ST. LUCIE PLANT UNIT NO. 1

AMENDMENT TO FACILITY OPERATING LICENSE

Amendment No. 13
License No. DPR-67

SUPPORTING AMENDMENT NO. 13 TO LICENSE NO. DPR-67

Figure 3.2-1 Allowable Peak Linear Heat Rate vs Burnup

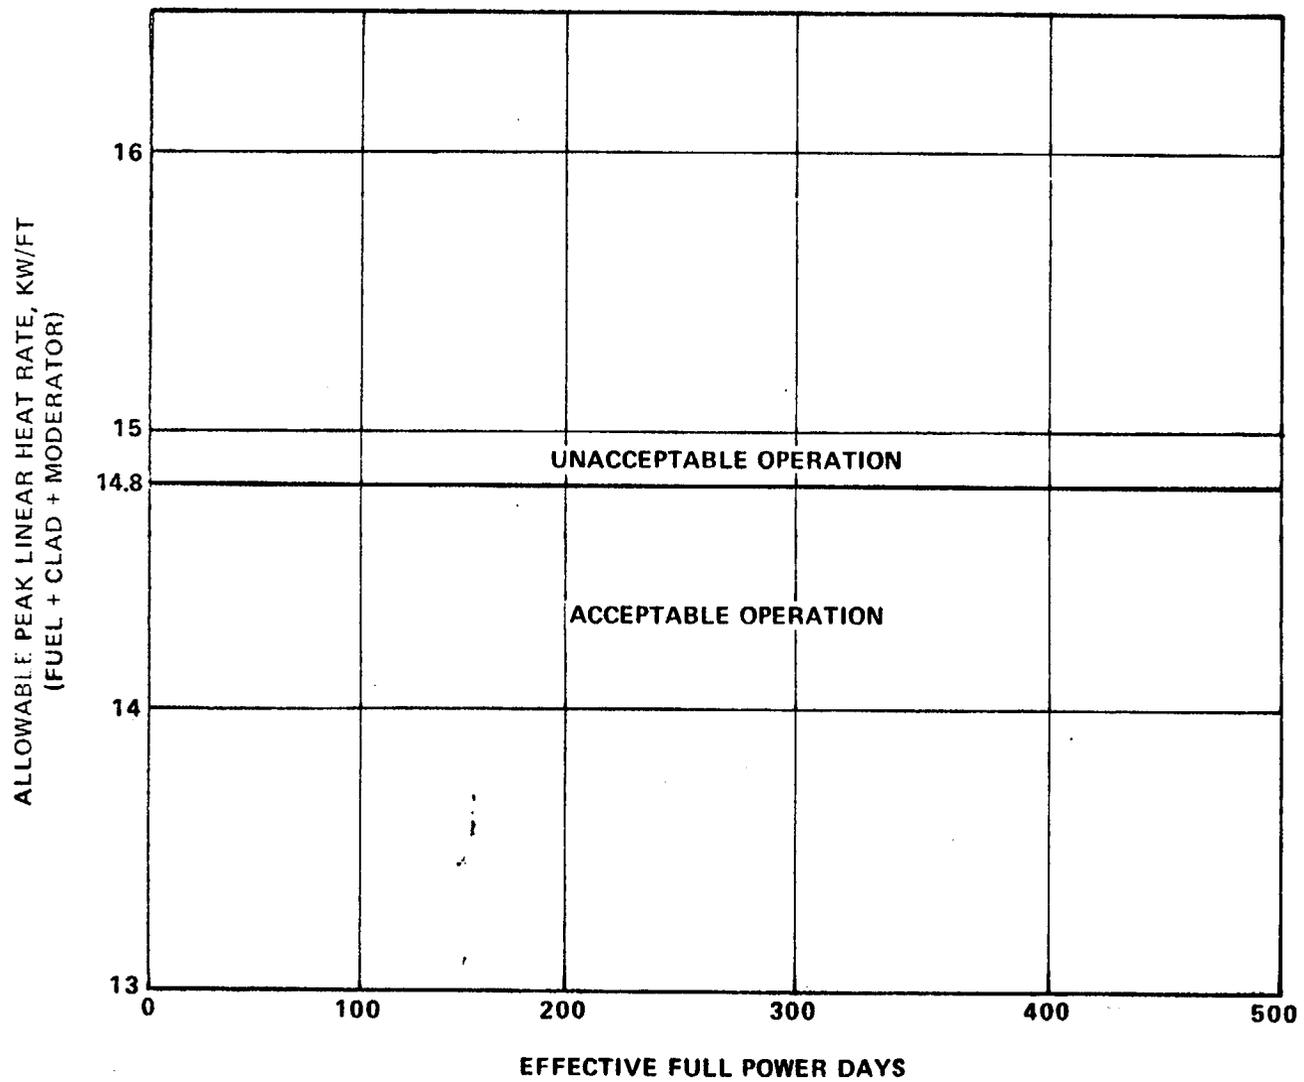
The amendment (1) terminates NRC's June 17, 1976 "Order for Modification of License" which had placed an interim power restriction of 90% of full power, an interim restriction on peak linear heat generation rate of 12.7 kW/ft and interim restrictions related to reactor coolant flow rate, (2) authorizes 100% power operation, (3) revises the peak linear heat generation rate limit in Technical Specifications to 14.8 kW/ft, and (4) reinstates Technical Specification limits based on a reactor coolant flow rate of 370,000 gpm.

Corresponding to the results of the corrected ECCS calculations described above, the licensee submitted a proposed change to the St. Lucie Unit No. 1 Technical Specifications.⁽⁵⁾ The proposed change increases the allowable peak linear heat generation rate from the interim limit of 12.7 kW/ft to 14.8 kW/ft shown in Figure 3.2-1 on page 3/4 2-3 of the Technical Specifications.

Based on our review of the corrected ECCS calculations, we conclude that the proposed Technical Specification modification is acceptable.
